**Department of Economic and
Development Services
Planning Division**

**PLANNING COMMISSION STAFF REPORT
PUBLIC HEARING**

Application Types	Type III Design Review
Application Numbers	DR 2015-02, VAR 2015-01
Project Description	The applicant requests a Design Review for six commercial buildings totaling approximately 30,000 square feet of gross floor area, and a Variance to the requirement for a screening wall abutting residential development along Robin Avenue.
Project Location	3001 Newberg Highway, tax lot 052W12BC06600
Zoning	Commercial General (CG)
Property Owner	Master Development, LLC
Applicant	Schirmer Satre Group
Planner Assigned	Jim Hendryx, Economic and Development Services Director
Application Received	August 21, 2015
Application Complete	November 12, 2015
120-Day Deadline	March 11, 2016
Date of Staff Report	December 2, 2015
Date of Public Hearing	December 10, 2015

Location of Required Screening Wall

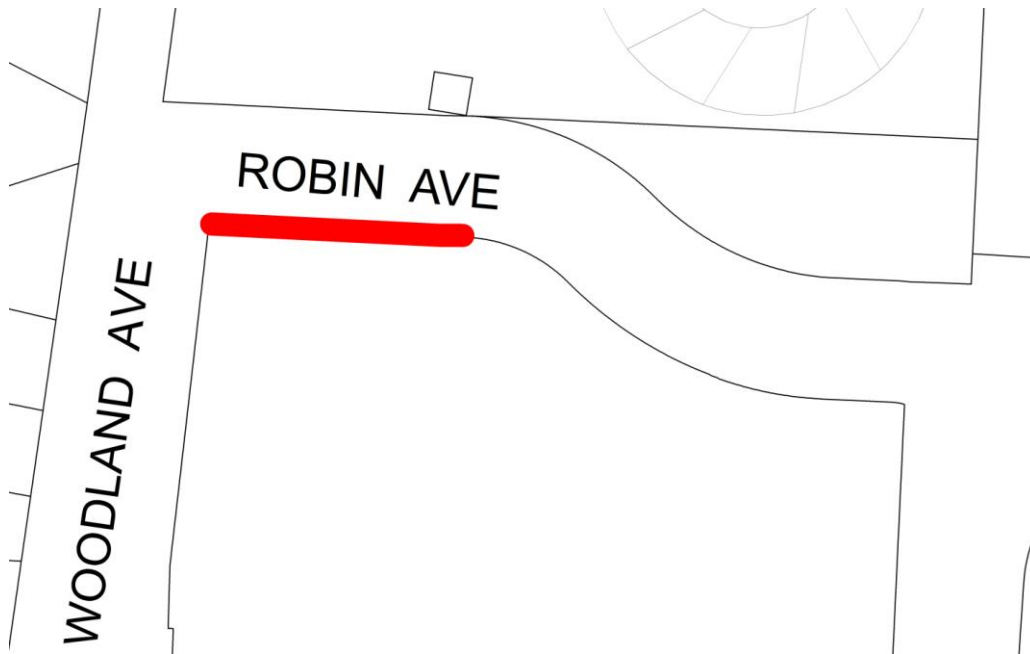
Table 3.06D requires screening between adjacent uses.

Finding: Section 5.03.12 A. The purpose of this Type III Variance is to allow use of a property in a way that would otherwise be prohibited by this Ordinance. Uses not allowed in a particular zone are not subject to the variance process. Standards set by statute relating to siting of manufactured homes on individual lots, siding and roofs of manufactured homes, and manufactured home and dwelling park improvements are non-variable.

Conclusions: The property is not “unbuildable by application of the WDO.” The requested variance would not alter existing patterns of traffic, drainage or other physical or natural systems, or be materially injurious to adjacent properties. The requested variance does not conflict with this ordinance nor the Woodburn Comprehensive Plan.
